HEART OF POLE PATCH PHASE 3

Preliminary Subdivision

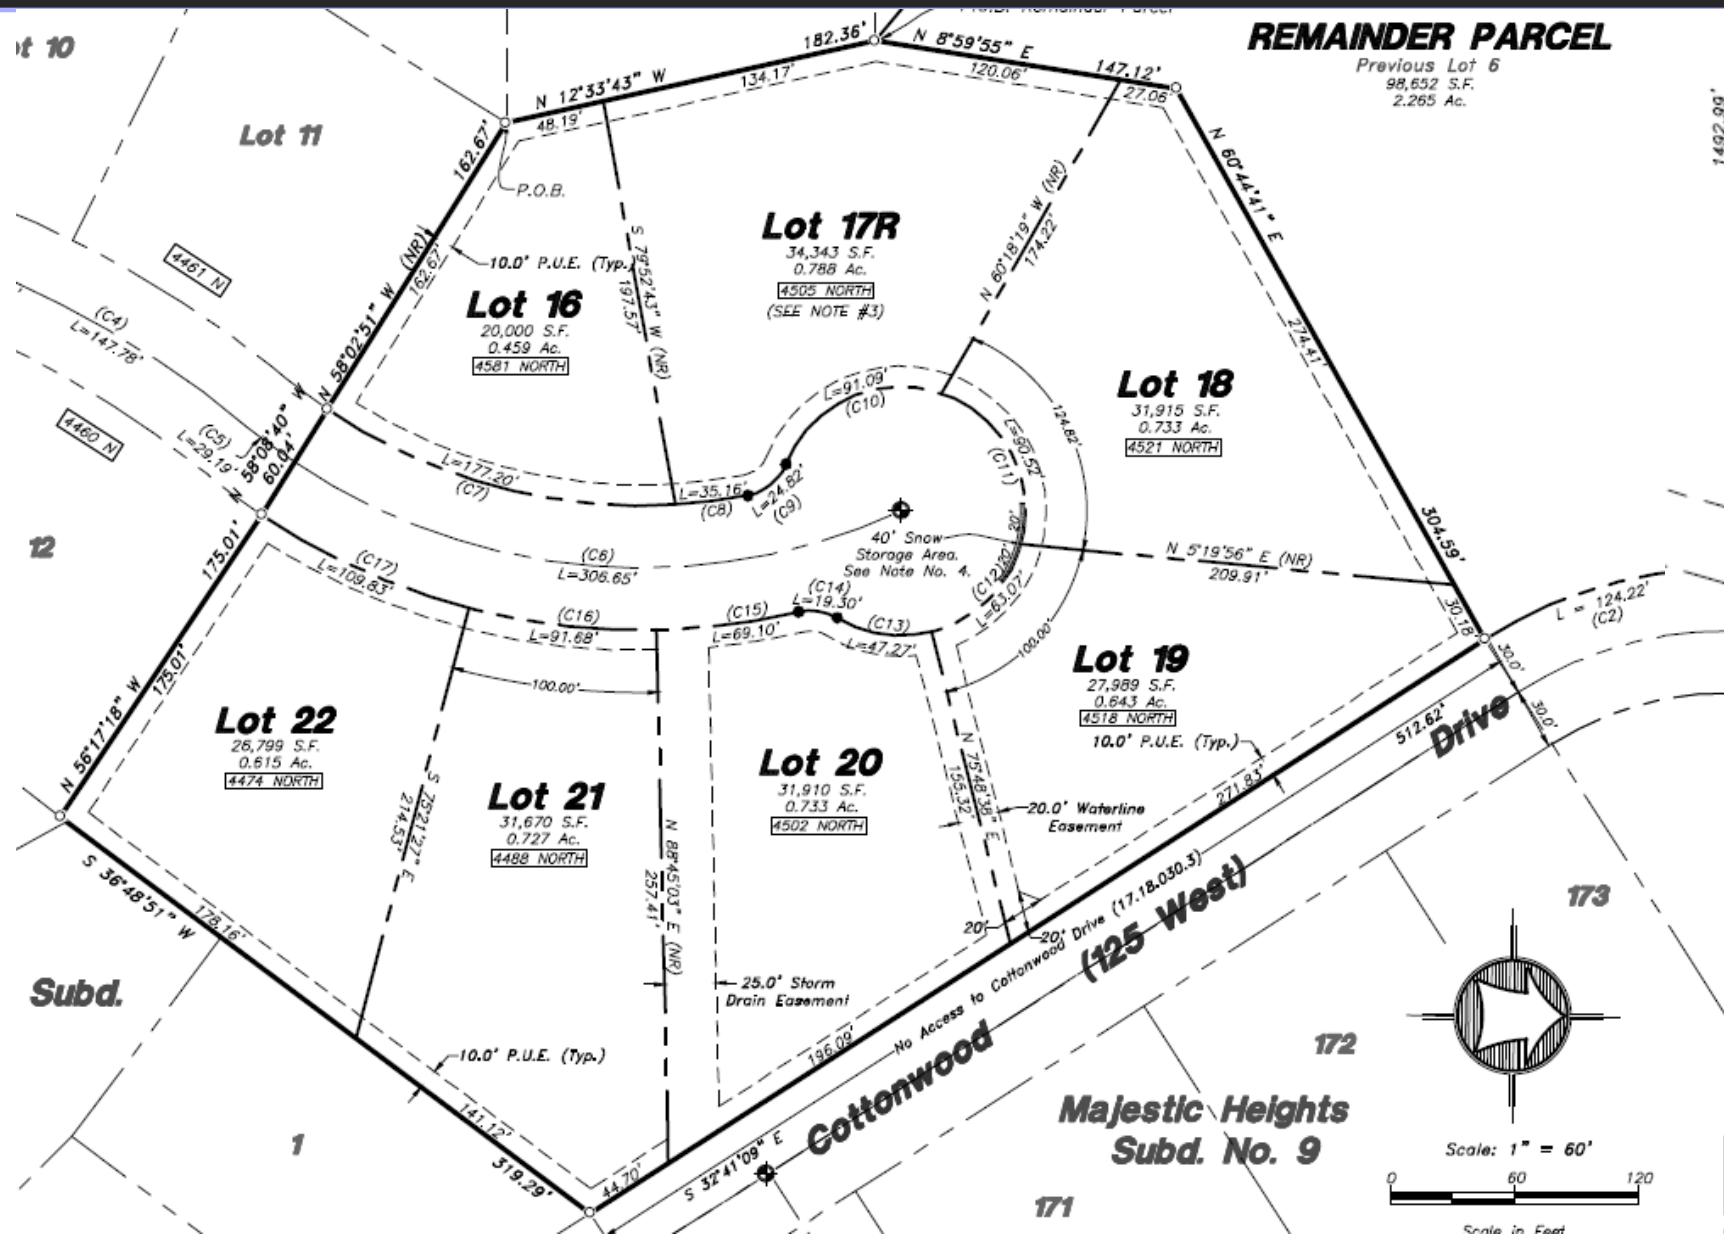
- Correction – 7 lots
- Fire Flow
- Lot sizes
- Easements
- Detention
- Remainder Parcel – What does that mean?
- Site walk on Cottonwood Dr Request:
- Developers have requested to not put the sidewalk on the west side of Cottonwood Dr due to the steep drop off and already not having access.
